**ENGINEERING REPORT**

**ANNUAL CCR LANDFILL INSPECTION  
40 CFR §257.84(b)**

**FAYETTE POWER PROJECT  
COMBUSTION BY-PRODUCTS LANDFILL**

**PREPARED BY  
LCRA ENGINEERING SERVICES  
January 12, 2018**

**PHOTO 1 – View of North Embankment drainage culverts looking Northeast (11-8-2017)**

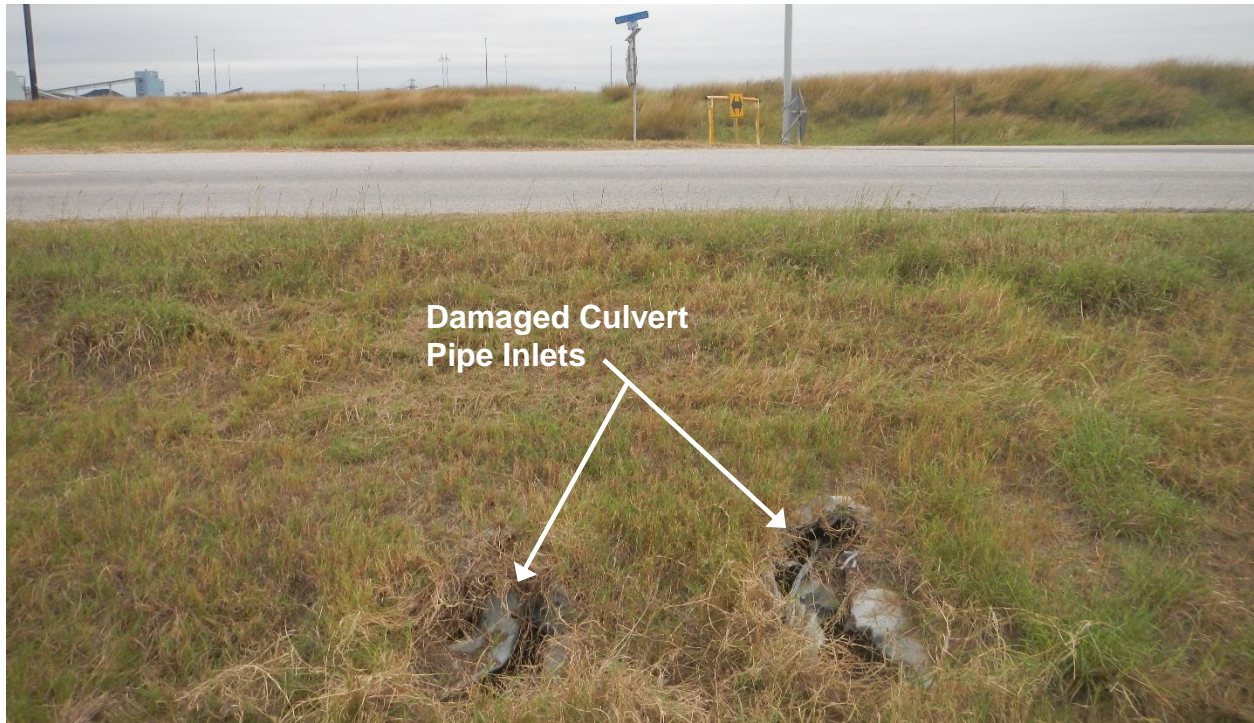
(1) Minor damage was identified at one of the corrugated metal drainage culverts which convey non-contact runoff from the closed northern slope section beneath the Austin Loop plant road. The mitered end matching the slope was bent and partially blocking the opening which will impede design flow. It is likely the metal culvert inlets were bent inwards during grass mowing activities and should be repaired to ensure proper drainage is maintained. (See Photo 1).

- Item 2017-001, Repair damaged inlet sections of corrugated metal drainage culverts which convey non-contact runoff from the northern embankment section beneath the plant road.
- Item 2017-002, Repair damaged corrugated metal drainage culvert ends near the intersection of Future Subcell 2A, 2B and Existing Subcell 2D, which convey contact runoff via the Runoff Channel from Existing Cell 1 beneath the access road to the Existing Runoff Retention Pond..
